# Final Program Environmental Impact Report for the Uptown Community Plan Update

Project No. 380611 SCH No. 2016061023 September 2016

# FINAL ENVIRONMENTAL IMPACT REPORT

<u>UPTOWN COMMUNITY PLAN UPDATE</u>: CITY COUNCIL APPROVAL AND ADOPTION of an update to the Uptown Community Plan; Adoption of General Plan Amendments; Adoption of the Uptown Impact Fee Study; Amendments to the Land Development Code; Repealing the Mid-City Communities Planned District Ordinance (PDO); Repealing the West Lewis Street PDO; Rescinding the Interim Height Ordinance; and Rezoning of the Community Plan areas with Citywide zones.

FIGURE 2-4 Existing Land Use

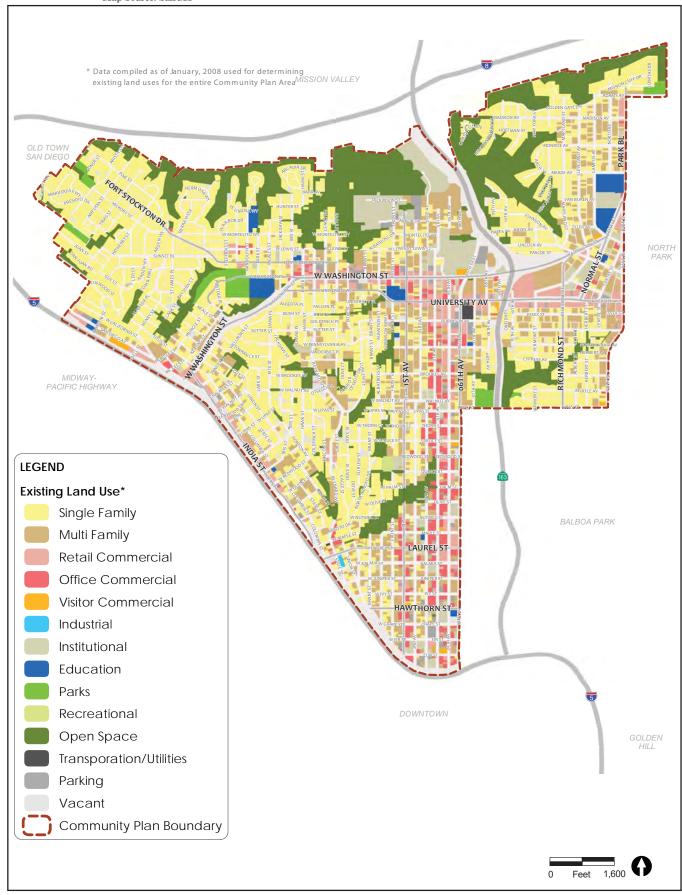
C18-5	2.3.1.1 - Existing Land Uses	2-6 - 2-9	Where did the information for Table 2-1, Figure 2-4, and subsections a, b, c, and d come from? The contradictions between the table, figure, and subsections are too numerous to name outright, but how, for example, does one reconcile the fact that Figure 2-4 shows the area around 5th and University as Mixed Used (73-110 du/ac) when, in fact, there are very few residential units in this area and, furthermore, that Table 2-1 does not even list Mixed Use as a category?	CEQA Guideline 15125(a)

C18-5 Table 2-1 in the PEIR represents the number of acres associated with actual land uses on the ground. Figure 2-4 that was provided in the Draft PEIR was revised in the Final PEIR to show existing land uses based on SANDAG data. The original Figure 2-4 included in the Draft PEIR represented the land uses envisioned through implementation of the adopted Community Plan and thus, showed the area around University Avenue and 5th as Mixed-Use with a residential density of 75-110 du/ac. Regardless of the updated figure, both the Draft and Final PEIR provide an adequate representation of existing physical conditions in the Uptown CPU area and the environmental analysis is based on the appropriate baseline of existing physical conditions.
